SUBJ: Florida Crushed Stone Company, Inc. (PSD-FL-227)

RE: Completeness Review of Air Construction Permit Application to Modify the Approved Second Cement Kiln for Florida Crushed Stone (FCS)

RE: Completeness Review of Air Construction Permit Application to Modify the Approved  
Second Cement Kiln for Florida Crushed Stone (FCS)

SUBJECT: Florida Crushed Stone - Cement Plant No. 2  
Permits No. AC27-274892 and PSD-FL-227 (A)  
Application submitted on September 11, 1996  
Completeness/Sufficiency Review

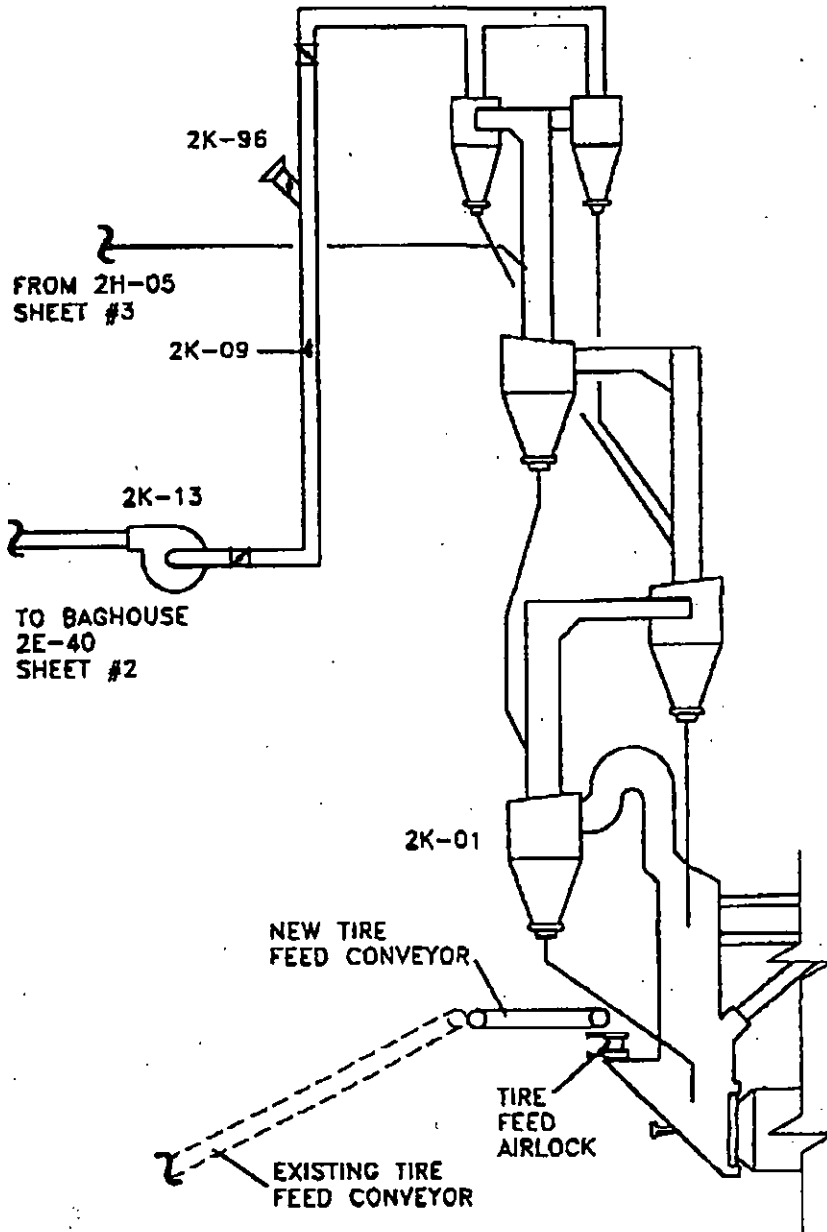
2. Provide a description and diagram of the tire feeder mechanism. Provide the technical specifications for the proposed tire feeder system.
3. Describe the process design and good combustion practices (GCP) that will be used to optimize control of proposed emissions of NO<sub>x</sub>, CO, SO<sub>2</sub>, and VOCs (e.g., process controls such as oxygen levels and temperature).

- (2) Whole tires and tire derived fuel (TDF, i.e., shredded tires) are fed to the kiln at the raw material inlet side of the kiln at the base of the preheater/precalciner through an airlock. Attached is a process flow diagram showing the tire feeder mechanism. The existing tire feed conveyor system for the existing FCS kiln will be modified to include a second conveyor system for delivering tires to the proposed second kiln. Also attached is an October 10<sup>th</sup> letter from Mr. Charles Allen describing the modifications required to the existing tire feeder mechanism and the operation of the airlock for the proposed kiln.

The Tire feeder mechanism is composed of two horizontally mounted slide gates. These gates are pneumatically operated and working in sequence provide a lock to prevent false air from entering the Pyro-processing system as tires are discharged into the preheater just above the kiln inlet. The top or upper slide gate acts as a weather gate and opens allowing a tire to enter the chamber between gates. After entry, the upper gate closes and the lower gate operates to allow passage of the tire without air infiltration.

- B-01 Supply conveyor (modified) (exists) - supplies maximum 1.33 TPH to kiln line (1) and 1.44 TPH to kiln line (2).
- B-02 weigh scale (modified) (exists) - PC controlled and remotely operated by plant control system to supply both kiln lines.
- B-03 Incline conveyor (modified) (exists) - Accepts tires from B-02 scale and delivers to kiln line (1) or 2B-06 diverter.
- 2B-06 Diverter (New) - Diverts tires from B-03 incline conveyor to 2B-03 conveyor (line 2)
- 2B-03 Conveyor (New) - Delivers tires from 2B-06 diverter to 2B-04 weather gate.
- 2B-04 Weather Gate (New) - Works in sequence with 2B-05 gate to provide air lock for line 2 preheater.
- 2B-05 Slide gate (New) - Works in sequence with 2B-04.
